RotorSport UK Ltd Service Bulletin (Permit)

Title: Replacement oil pump adaptor		
SB-113 Iss1	Related documents Modification: MC-None CCAR No.: None	Compliance Category: OPTIONAL or RECOMMENDED or MANDATORY
Applicability		
Aircraft type & model: MTOsport, Calidus, Cavalon	Aircraft serial Nos. affected: Those aircraft fitted with an oil pressure switch and warning light	
The maintenance manual to be referenced is this stated or subsequent issue.		RSUK0044 Iss 8 RSUK0061 Iss 6 RSUK0288 Iss 5
<p>This form is the response from RotorSport UK Ltd either against a problem found in the product in service requiring a containment or rectification action, or as service information for aircraft modification incorporation. For help, contact RotorSport on 44(0)1588 505060, or email compliance@rotorsport.org.</p> <p>The technical content of this document is approved under the authority of the UK CAA Design Organisation Approval Ref: DAI/9917/06</p>

Fig.1 Oil pressure switch

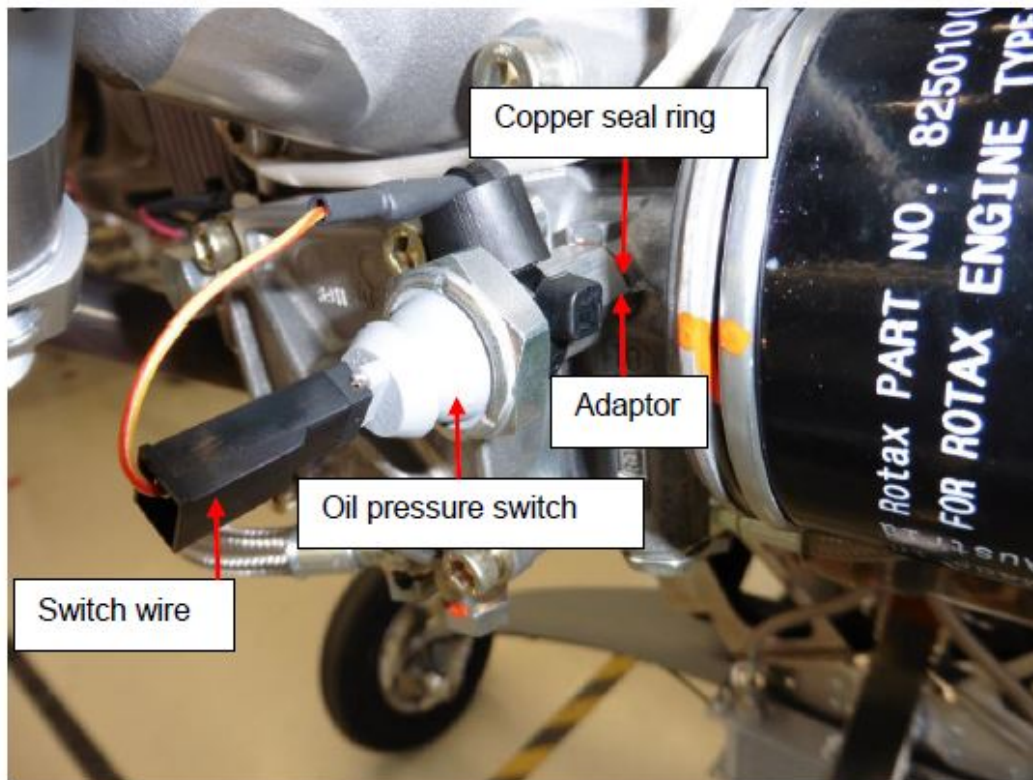
For those aircraft equipped with an oil pressure warning light, a pressure switch is fitted to the oil pump casing by means of a small threaded adaptor. A case was found during initial service of an overtightened adaptor leading to breakage. This bulletin introduces a part less likely to break due to overtightening

1. For Calidus and Cavalon remove the engine cowlings as described in the aircraft's AMM
2. Remove the oil pressure switch connector (Fig 1)
3. Remove cable ties and spacer (Fig 1)

4. Unscrew the oil pressure switch complete with adaptor from the oil pump housing (Fig 1).
Caution: a small amount of oil will escape, be prepared to collect/mop-up

6. Clamp the new adaptor in a vice and using Loctite 542 on the threads fit the oil pressure switch and washer to the adaptor (Fig 2)
7. Apply Loctite 542 to the adaptor and oil pump housing. Install with a new copper sealing ring and tighten to 10Nm

Fig. 2 Apply Loctite 542
